SLOUGH MULTIFUEL EXTENSION PROJECT

Planning Inspectorate Ref: EN010129

**Document Ref: 9.2 – Applicant’s Responses to the Examining
Authority’s First Written Questions (ExQ1)**

Applicant: SSE Slough Multifuel Limited

Slough Multifuel Process Diagram

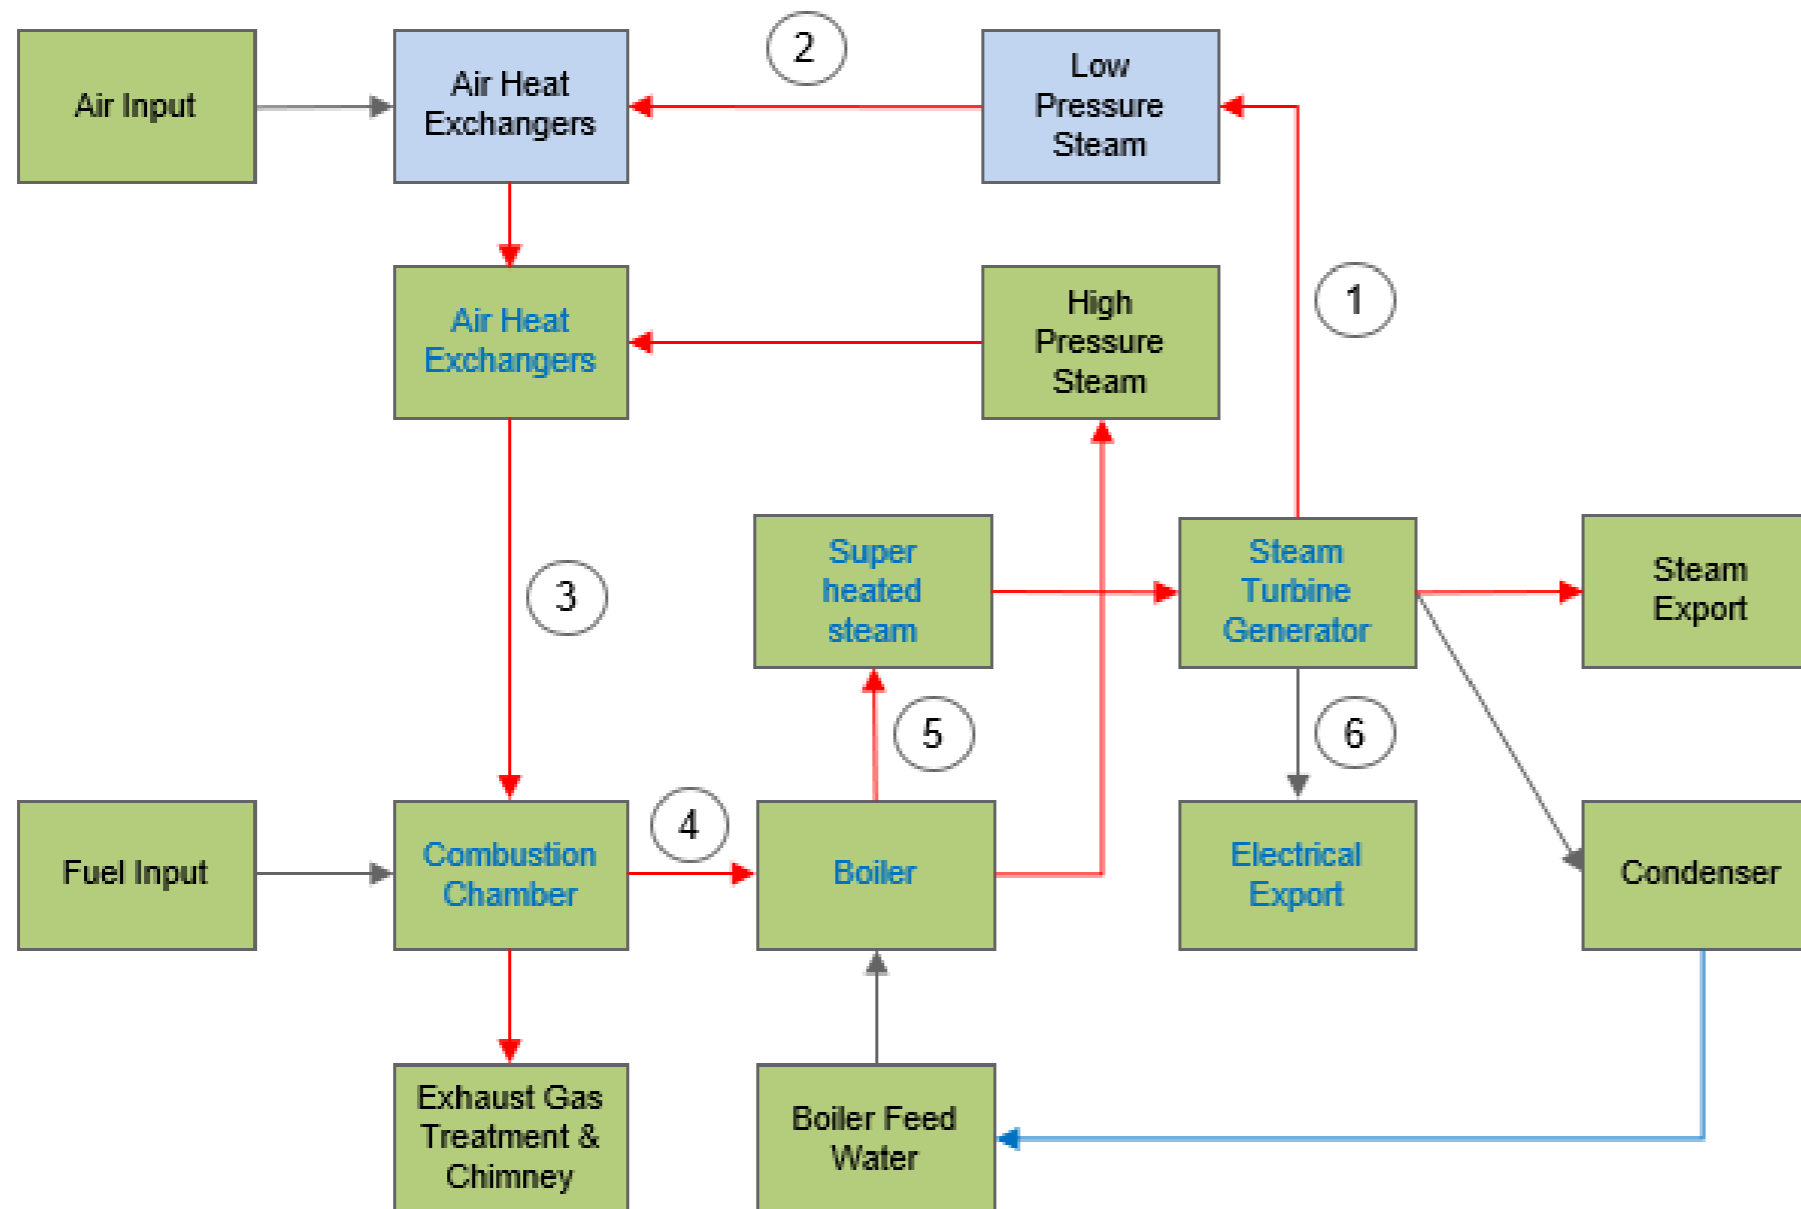
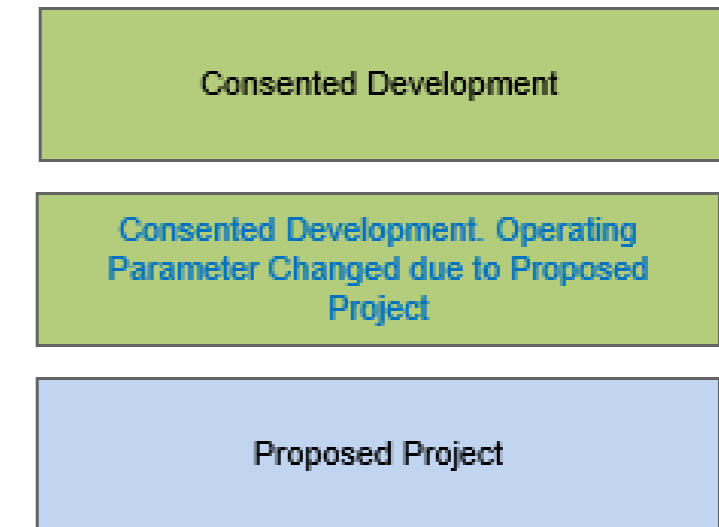
Air Quality and Emissions			
Q1.3.1	Applicant	Paragraphs 2.5.1 to 2.5.3 of ES Chapter 2: The Proposed Project [APP-027] and paragraph 8.1.5 of ES Chapter 8: Air Quality [APP-033], outline how the Proposed Development seeks to increase the generating capacity of the consented scheme. Please clarify the point at which (within the Energy from Waste process) the efficiencies and increased gross electricity generation capacity would be delivered by ‘interventions’ as part of the Proposed Development. For the ExA to better understand these points, the Applicant is requested to provide a process flow(s)/schematic block diagram(s) showing the Energy from Waste process which clearly identifies these interventions. In responding please have particular regard to the combustion element in demonstrating the assertions that “The Proposed Project does not introduce any new emissions nor change the exhaust gas parameters” (paragraph 8.8.16 of [APP-033]) and that the pre-heating of combustion air would be achieved without the use of additional fuel [APP-027, paragraph 2.5.1].	Further to the answer supplied in Q1.2.4 part b, the Consented Development includes 2 boilers with a total thermal capacity of 183MWt. The Proposed Project makes no changes to the boilers supplied for the consented development, their fuel consumption, or emissions. The intervention from the Proposed Project occurs where low pressure steam is extracted from the steam turbine and fed to air heat exchangers. The steam fed to the air heat exchangers increases the temperature of the combustion air being fed into the boilers which allows more steam to be produced for the same amount of fuel. The Proposed Project recovers energy which would otherwise have been wasted in the process. Please refer to the Slough Multifuel Process Diagram and Slough Multifuel Process Overview contained in Appendix 1 of this document.

- ① Low pressure steam is extracted from the steam turbine
- ② Low pressure steam is fed into new air heat exchangers increasing the combustion air temperature.
- ③ Combustion air is fed into the combustion chamber at increased temperature.
- ④ Increased energy recovery
- ⑤ Increased steam generation
- ⑥ Increased electrical output
